Access Compliance Report

Public Rights-of-Way

Intersection ID: 24420	Main Street: HILLDALE_WY	Cross Street: SWANS_RUN_RD	Location: SW
ADA ID: AAD3CF7C9F9A	Ramp Type: BlendTrans2	Initial Pass/Fail: Fail	Overall Compliance: No
		Severity Score: 8.75

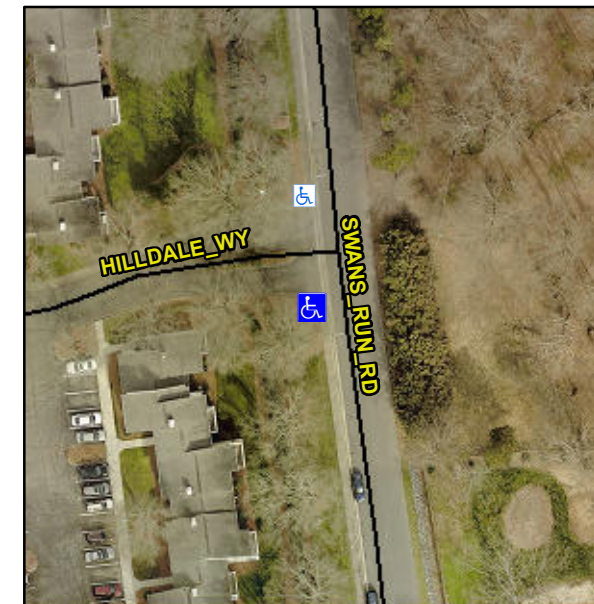
Not Found, R304.5.1

Compliance	Description	Data	Compliance	Description	Data
N/A	Ramp Length (in)	48.0	Yes	BlendTrans Slope (%)	4.3
No	Ramp Width (in)	43.0	Yes	BlendTrans XSlope (%)	0.6
N/A	Flare Type LT	N/A	N/A	Flare Type RT	N/A
N/A	Flare Slope LT (%)	N/A	N/A	Flare Slope RT (%)	N/A
N/A	Flare Traversable LT?	N/A	N/A	Flare Traversable RT?	N/A
N/A	Landing Length (in)	N/A	N/A	DWS Provided?	N/A
N/A	Landing Width (in)	N/A	N/A	DWS Contrast?	N/A
N/A	Landing Slope (%)	N/A	N/A	DWS Length (in)	N/A
N/A	Landing X Slope (%)	N/A	N/A	DWS Full Width?	N/A
N/A	Landing Curb? (Y/N)	N/A	N/A	DWS Offset (in)	N/A
N/A	Shared Landing?	N/A			
N/A	Gutter Ponding?	N/A	N/A	Gutter Slope (%)	N/A
N/A	Gutter Lip Ht (in)	N/A	N/A	Gutter X Slope (%)	N/A
N/A	Painted X Walk1?	No	N/A	Painted X Walk2?	No
	X Walk 1 Direction	To E		X Walk 2 Direction	To N
	X Walk 1 Width (in)	N/A		X Walk 2 Width (in)	N/A
	X Walk 1 Slope (%)	6.5		X Walk 2 Slope (%)	3.8
	X Walk 1 X Slope (%)	3.0		X Walk 2 X Slope (%)	4.1

Remove & Replace Curb Ramp With Two New Directional Ramps or Equivalent.
